World Forum for Harmonization of Vehicle Regulations**Working Party on Passive Safety****Sixty-eighth session**

Item 13 of the provisional agenda

Regulation No. 134 (Hydrogen and Fuel Cell Vehicles)**Proposal for the 01 series of amendments to UN
Regulation No. 134 (Hydrogen and Fuel Cell Vehicles
(HFCV))****Submitted by the expert from the Netherlands ***

Model A

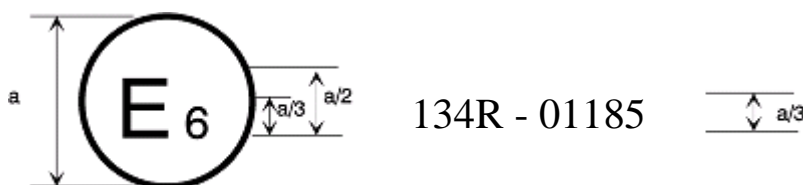
The above approval mark affixed to a vehicle/ storage system/specific component shows that the vehicle/storage system/specific component type concerned has been approved in Belgium (E 6) for its the safety-related performance of hydrogen-fuelled vehicles pursuant to Regulation No. 134. The first two digits of the approval number indicate that the approval was granted in accordance with the requirements of Regulation No. 134 in its original form already contained the 01 series of amendments at the time of approval.

Model B

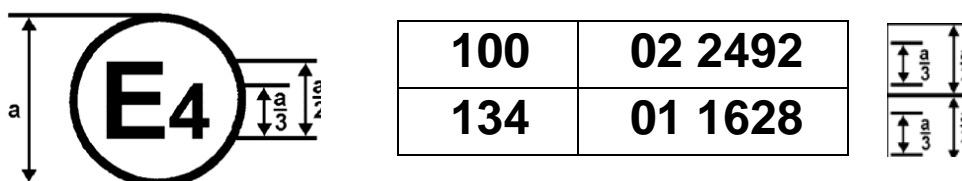
The above approval mark affixed to a vehicle shows that the road vehicle concerned has been approved in the Netherlands (E 4) pursuant to Regulations Nos. 134 and 100.* The approval number indicates that, at the dates when the respective approvals were granted, Regulation No. 100 was amended by the 02 series of amendments and Regulation No. 134 was still in its original form. **amended by the 01 series of amendments."**
